APPLICATION FOR PERMIT TO DRILL, DEEPEN, OR PLUG BACK

CASE DESIGNATION AND SERIAL NO. U-10344
6. IF INDIAN, ALLOTTEE OR TRIBE NAME _____
7. UNIT AGREEMENT NAME _____
8. FARM OR LEASE NAME South Clear Creek
9. WELL NO. _____
10. FIELD AND POOL, OR WILDCAT USA Lynda #1
11. SEC., T., R., M., OR BLK. AND SURVEY OR AREA Wildcat
12. COUNTY OR PARISH 13. STATE Sec 17, T15S, R7E
Emery Utah

SUBJECT: APD MINERAL EVALUATION REPORT

Usual Environmental Analysis

T15S, R7E, S.L.B. & M.

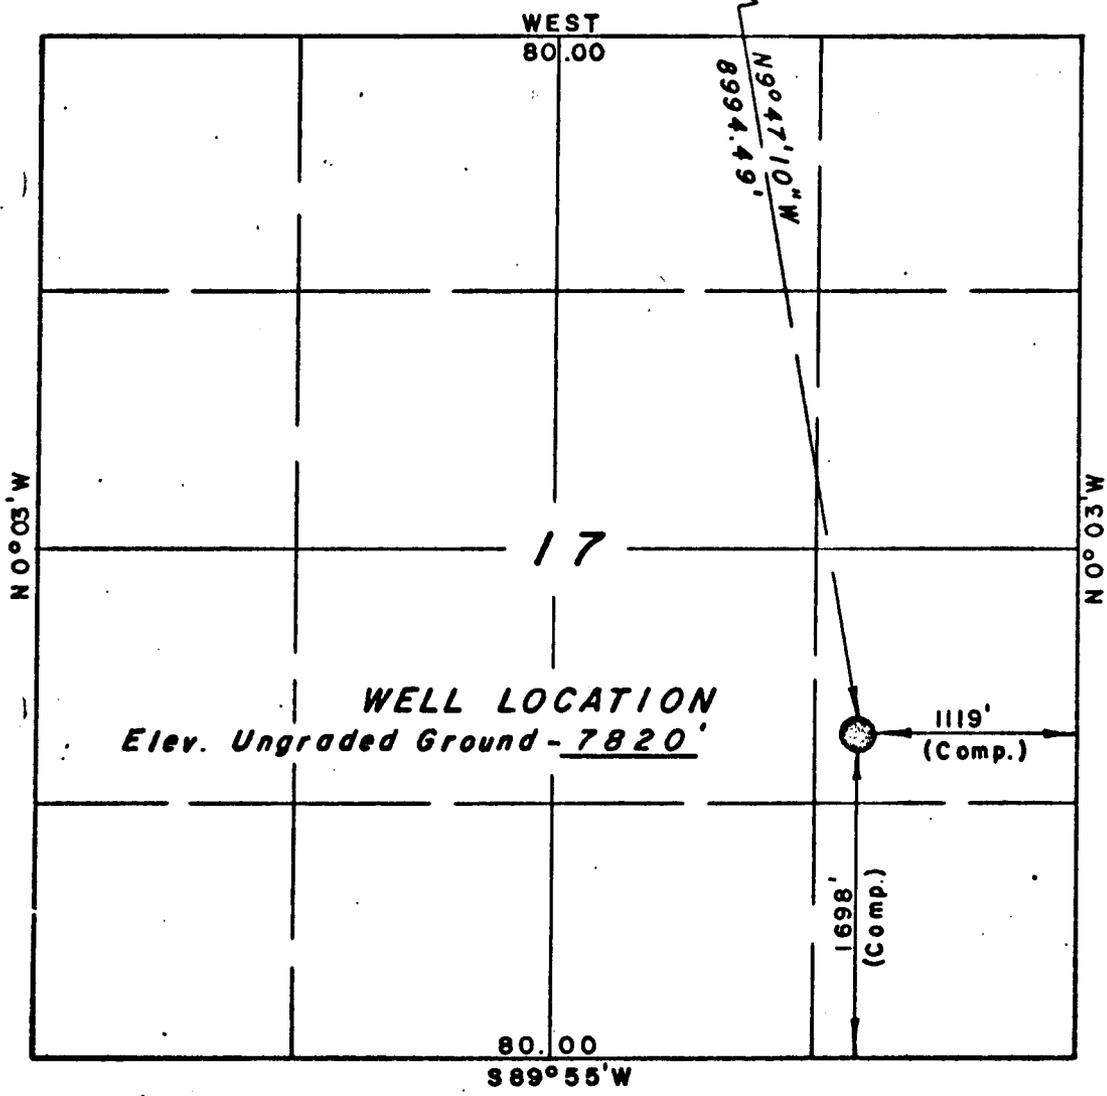
Location was moved approximately 125' northwest to conform with USFS & USGS recommendations at time of the joint onsite inspection.

Attached are copies of: New survey plat, new cut and fill plat, topo map, cross section diagram, and location layout.

Figure 1: Location of Energy Reserves Group proposed well USA Lynda #1, T. 15 S., R. 7 E., SIM, Carbon Co., Utah

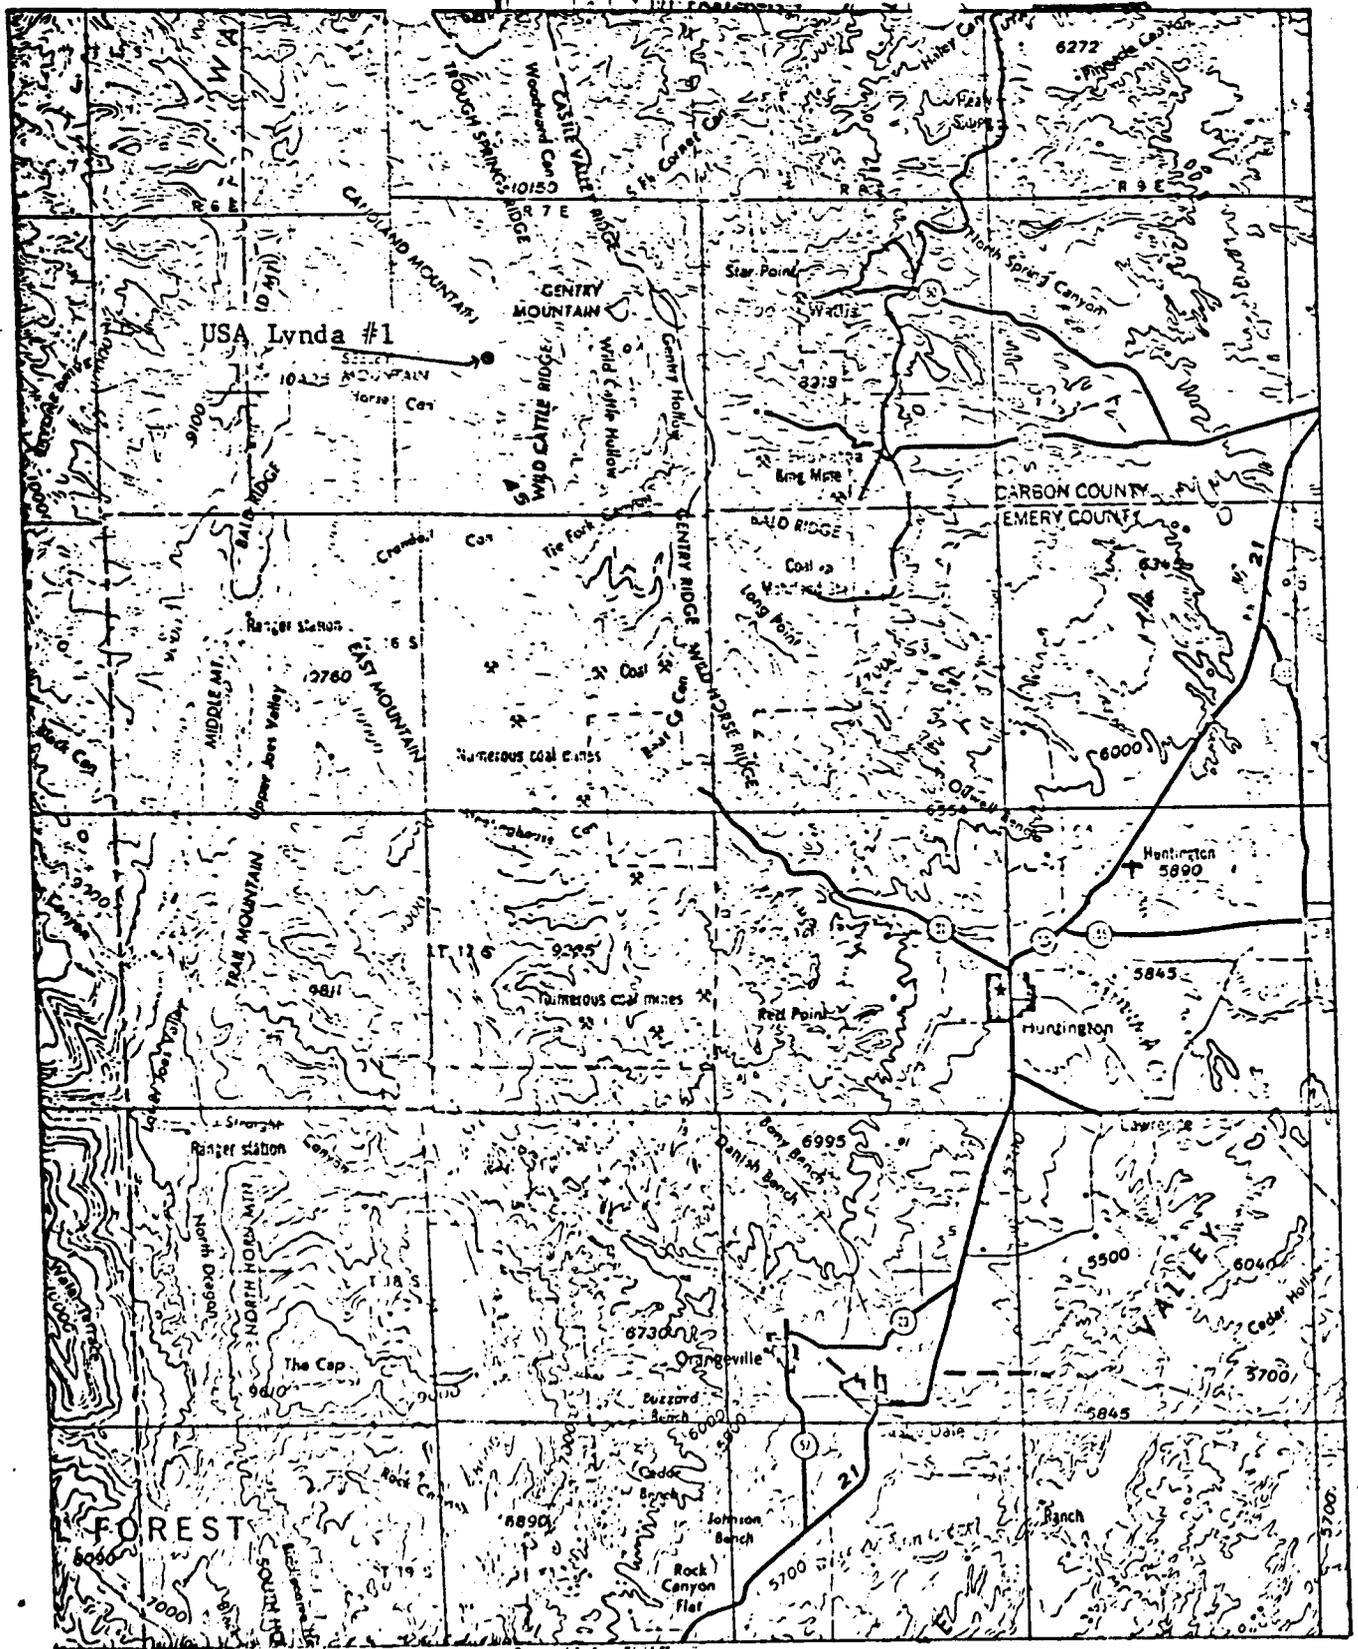
Topography - The proposed well site is located in the bottom of Huntington Canyon adjacent to State Highway 31 about 16 miles northwest of Huntington, Utah (figure 1). The well site is at an elevation of 7820 feet above sea level, and the area in the immediate vicinity of the pad exhibits moderate relief (figure 2). At the wellsite, the canyon bottom is less than 500 feet wide, and the canyon walls are very steep reaching to an elevation in excess of 9600 feet above sea level.
